Contract No. T200751201.01  
Federal Aid Project No. HPP-2005(028)  
NORTHEAST CORRIDOR IMPROVEMENTS, YARD TO RAGAN - CIVIL, STRU  
New Castle County

Enclosed is Addendum No. 2 for the referenced contract consisting of the following:

1. One (1) page, Bid Proposal Cover, revised, to be substituted for the same page in the Proposal.
2. Three (3) sheets, Construction Plans, sheets 3, 39, and 73, revised, to be substituted for the same sheets in the Plan Set and one (1) sheet, Construction Plans, sheet 71A, new, to be added to the Plan Set.

**NORTHEAST CORRIDOR IMPROVEMENTS,  
YARD TO RAGAN - CIVIL, STRUCTURE**

### DRAWING NO. G-1

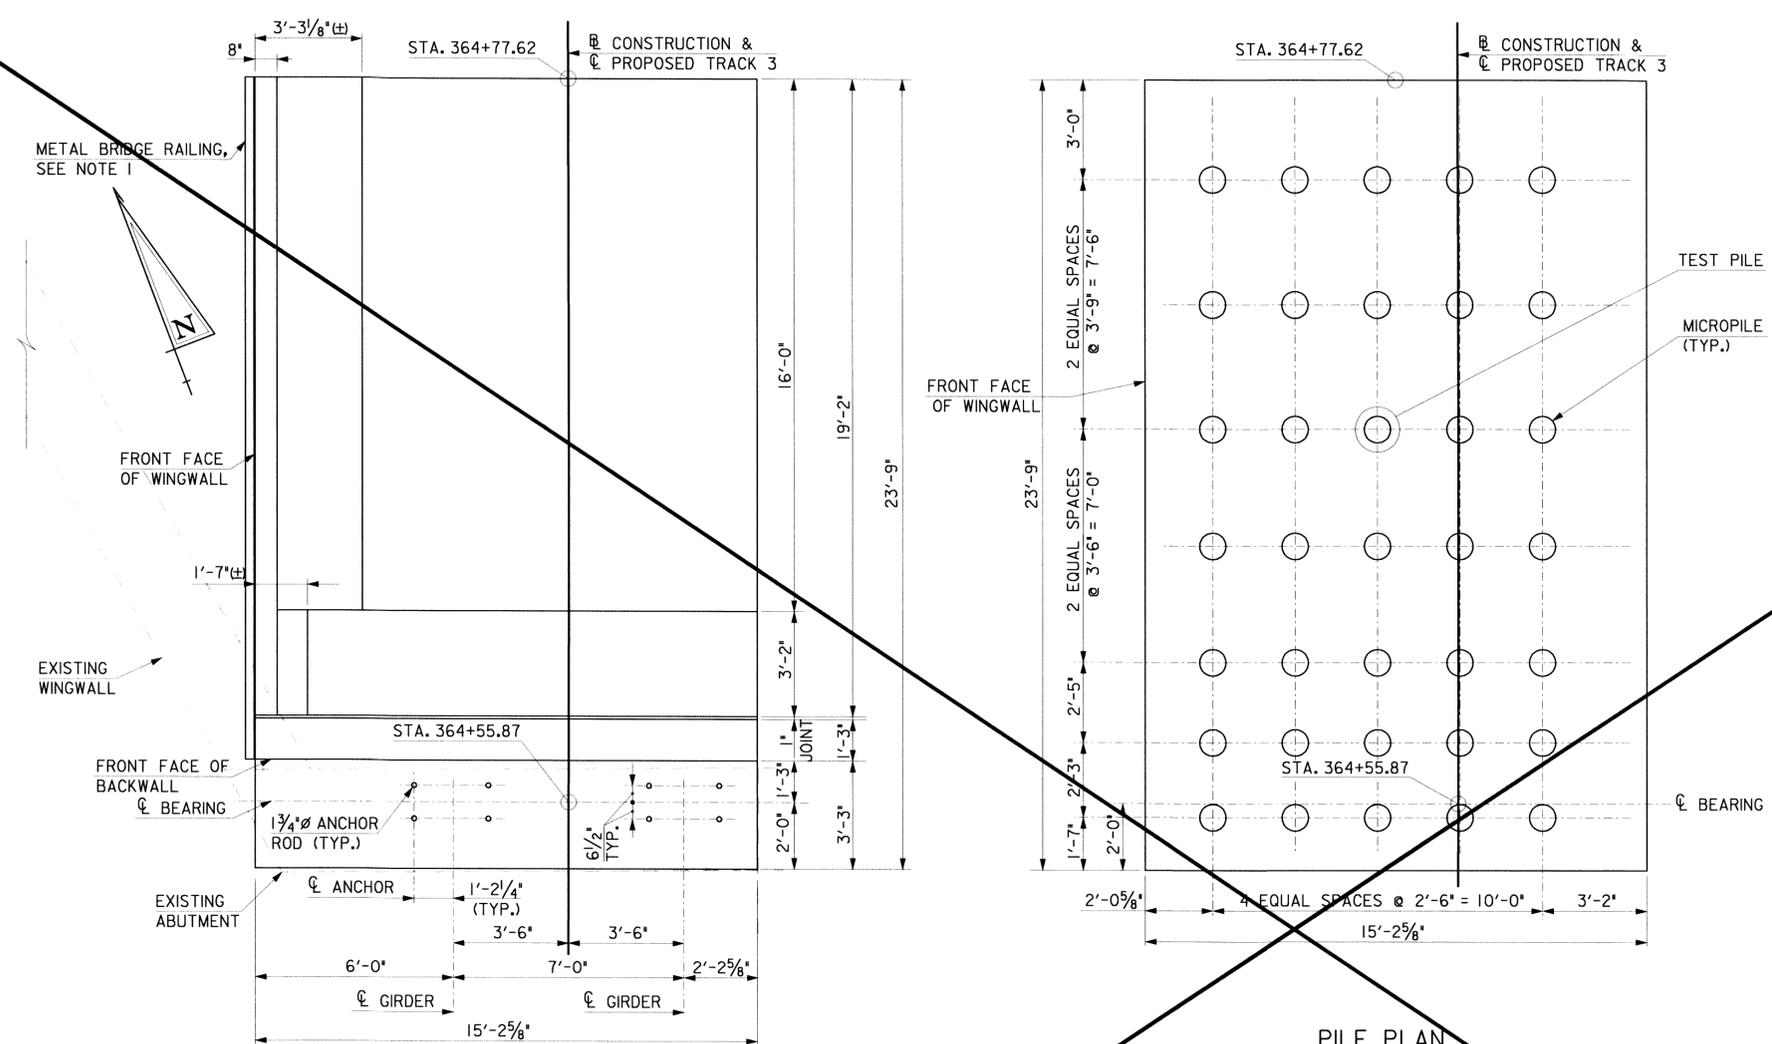
1. NO WORK SHALL OCCUR IN THE LITTLE MILL CREEK FROM ~~APRIL 1 THROUGH MAY 30~~ MARCH 15 TO MAY 31.
2. ALL CONSTRUCTION ACTIVITIES SHALL OCCUR WITHIN THE L.O.C. AS DESIGNATED ON THE PLAN SHEETS. ANY DEVIATION FROM THIS L.O.C. BY THE CONTRACTOR SHALL REQUIRE APPROVAL OBTAINED BY THE CONTRACTOR FROM A.C.O.E, DNREC, AND SHPO.

**DRAWING NO. S-3  
ABUTMENT B AND PILE PLAN  
MILL CREEK BRIDGE**

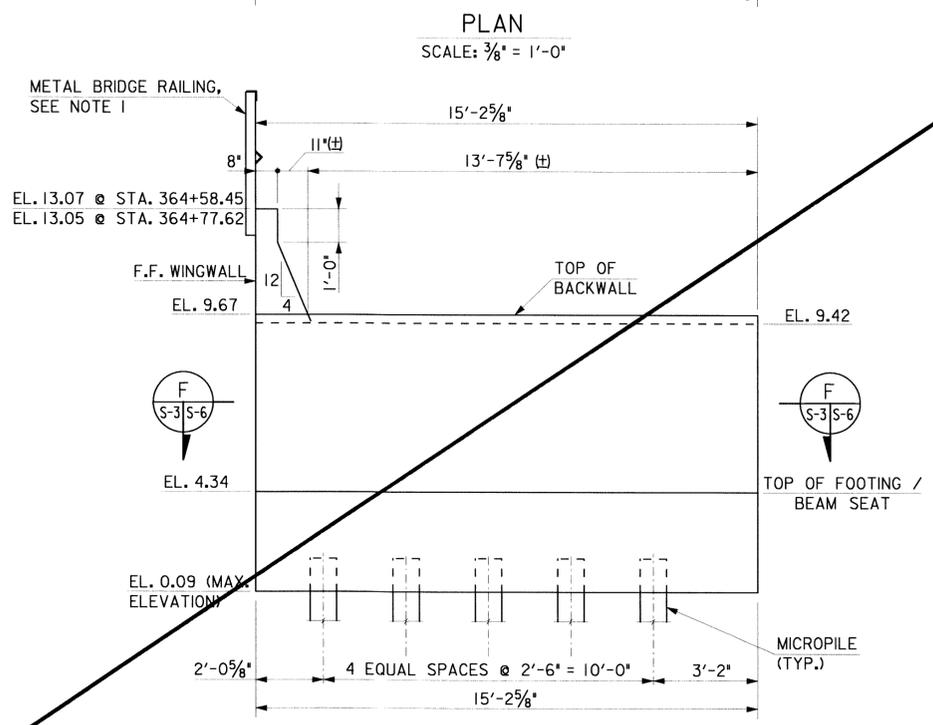
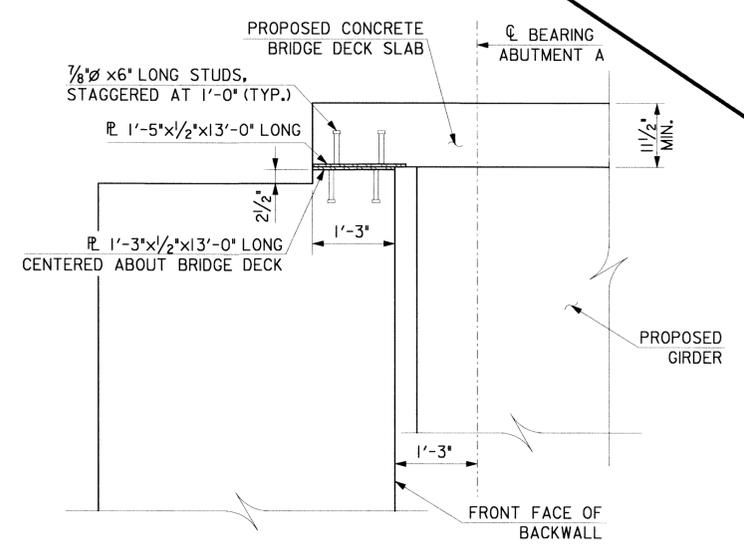
CONTRACT	COUNTY	F.A.P. NO.	SHEET NO.	TOTAL SHTS.
NEW CASTLE		N/A	39	140
<b>NEC COMMUTER RAIL IMPROVEMENTS WILMINGTON TO NEWARK, DE</b>				
DATE: APRIL 20, 2009				
REVISIONS				
1. Delete Sheet 9-23-11 TRB

**DRAWING NO. SOE-2**  
**TEMPORARY SUPPORT OF EXCAVATION**  
**THIRD TRACK**  
**NOT TO SCALE**

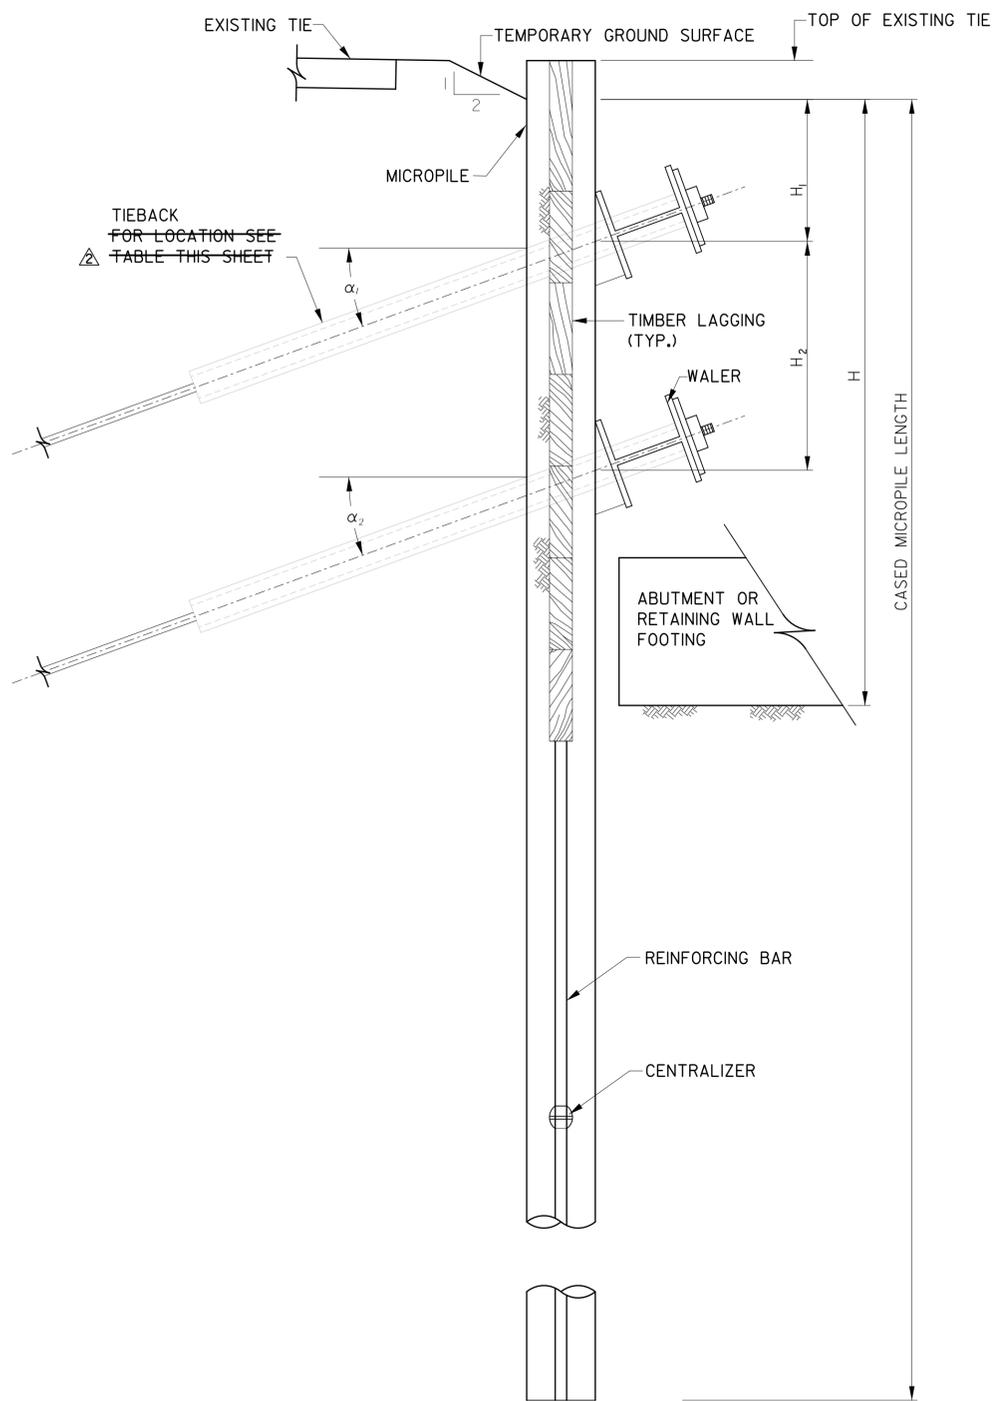
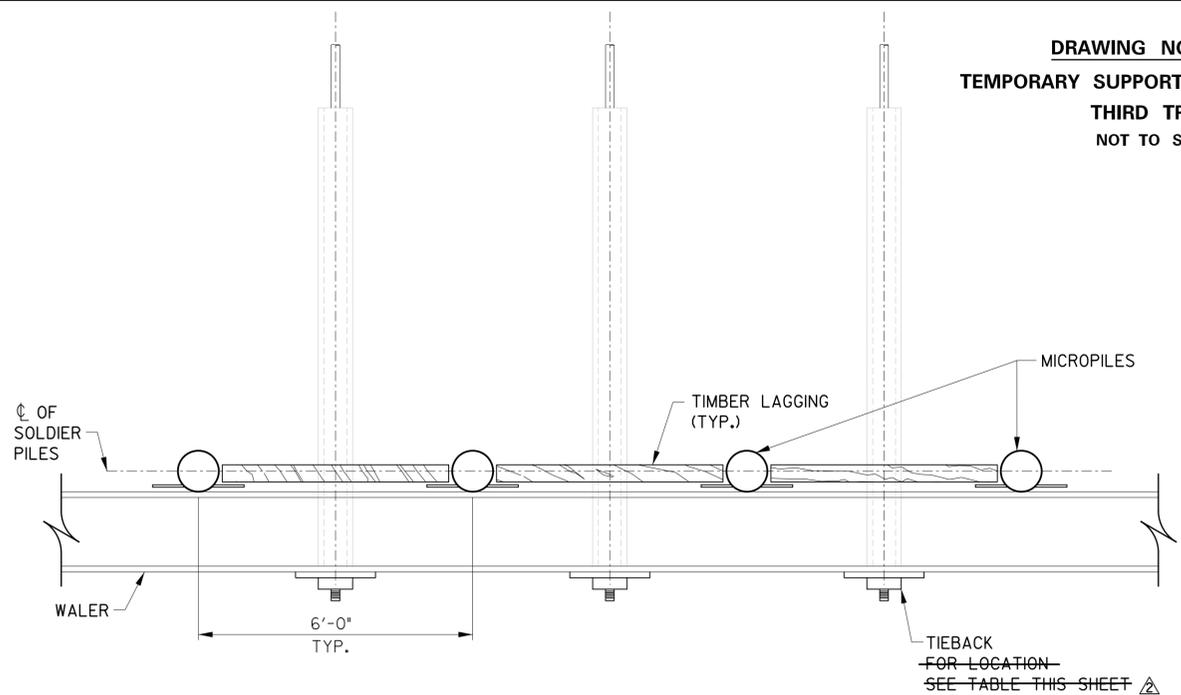
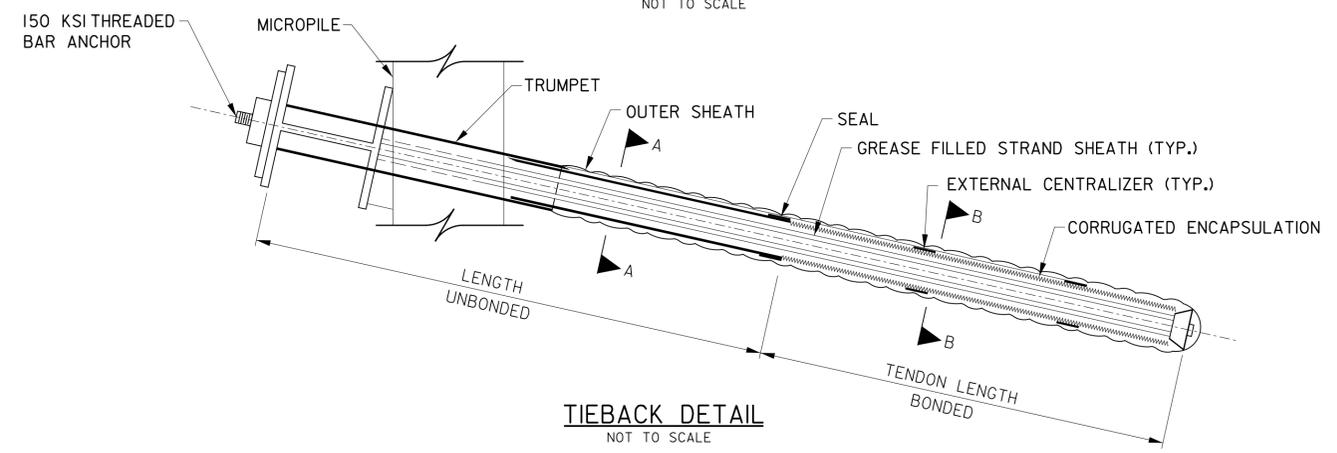
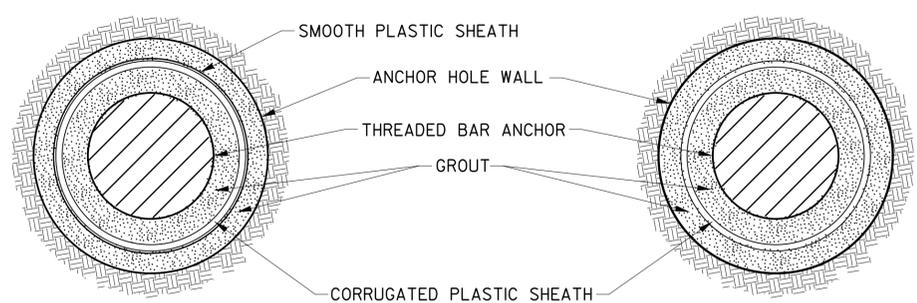
CONTRACT	COUNTY	F.A.P. NO.	SHEET NO.	TOTAL SHTS.
NEW CASTLE	N/A	N/A	73	140
<b>NEC COMMUTER RAIL IMPROVEMENTS WILMINGTON TO NEWARK, DE</b>				
DATE: APRIL 20, 2009				
<b>REVISIONS</b>				
△ DELETED TEXT-EHL, 2011-10-05

- NOTES:
1. FOR BORING AND DRIVE TEST, SEE DWG. NO SB-67-39 △ THROUGH DWG. NO SB-75-57. △
  2. WATER SHALL NOT BE USED FOR INSTALLATION OF MICROPILES AND TIE BACKS.
  3. MICROPILES SHALL BE CASED FOR THE ENTIRE LENGTH.
  4. THE MICROPILES SHALL EXTEND A MINIMUM OF 10 FEET INTO CONTINUOUS ROCK WITH NO VOIDS GREATER THAN 6-INCHES.
  5. TIEBACKS SHALL BE DRILLED IN PLACE WITH CASING. CASING SHALL BE EXTRACTED ONLY AS GROUT IS PLACED IN THE TIEBACK.
  6. THE LENGTH OF TIEBACKS SHALL BE DESIGNED TO BE WITHIN THE RIGHT-OF-WAY OF THE PROJECT. THE TIEBACKS SHALL EXTEND A MAXIMUM HORIZONTAL DISTANCE OF 39 FEET FROM THE CL OF EXISTING TRACK 3.
